Access Compliance Report

Public Rights-of-Way

Intersection ID: 28103	Main Street: COMMUNITY_HOUSE_RD	Cross Street: PROVIDENCE_RD	Location: NW
ADA ID: 313432984106	Ramp Type: Para	Initial Pass/Fail: Fail	Overall Compliance: No
		Severity Score: 12.5

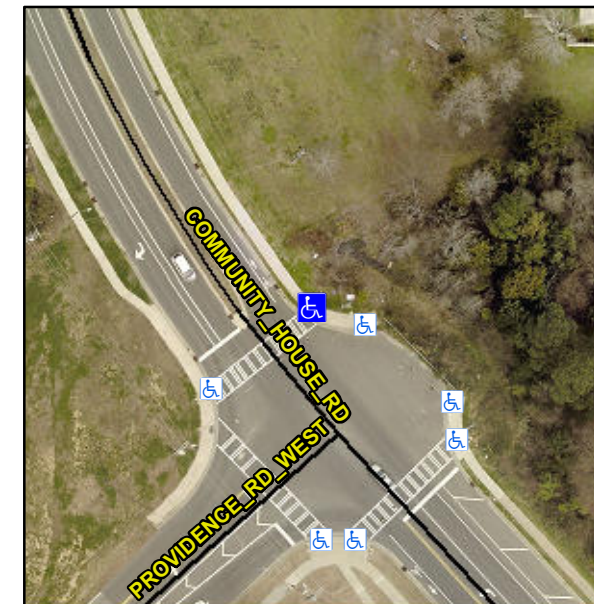
R304.3.2

Compliance	Description	Data	Compliance	Description	Data
N/A	Ramp Length LT (in)	57.0	N/A	Ramp Length RT (in)	57.0
Yes	Ramp Width LT (in)	62.0	Yes	Ramp Width RT (in)	59.0
No	Ramp Slope LT (%)	9.3	Yes	Ramp Slope RT (%)	5.6
Yes	Ramp XSlope LT (%)	0.9	Yes	Ramp XSlope RT (%)	0.9
N/A	Landing Length (in)	N/A	N/A	DWS Provided?	N/A
N/A	Landing Width (in)	N/A	N/A	DWS Contrast?	N/A
N/A	Landing Slope (%)	N/A	N/A	DWS Length (in)	N/A
N/A	Landing X Slope (%)	N/A	N/A	DWS Full Width?	N/A
N/A	Landing Curb? (Y/N)	N/A	N/A	DWS Offset (in)	N/A
N/A	Shared Landing?	N/A			
N/A	Gutter Ponding?	N/A	N/A	Gutter Slope (%)	N/A
N/A	Gutter Lip Ht (in)	N/A	N/A	Gutter X Slope (%)	N/A
N/A	Painted X Walk1?	Yes	N/A	Painted X Walk2?	N/A
	X Walk 1 Direction	To SW		X Walk 2 Direction	N/A
N/A	X Walk 1 Width (in)	129.0	N/A	X Walk 2 Width (in)	N/A
	X Walk 1 Slope (%)	3.8		X Walk 2 Slope (%)	N/A
	X Walk 1 X Slope (%)	0.2		X Walk 2 X Slope (%)	N/A
N/A	Ramp inside XWalk1?	Yes	N/A	Ramp inside XWalk2?	N/A

Remove & Replace Entire Ramp.
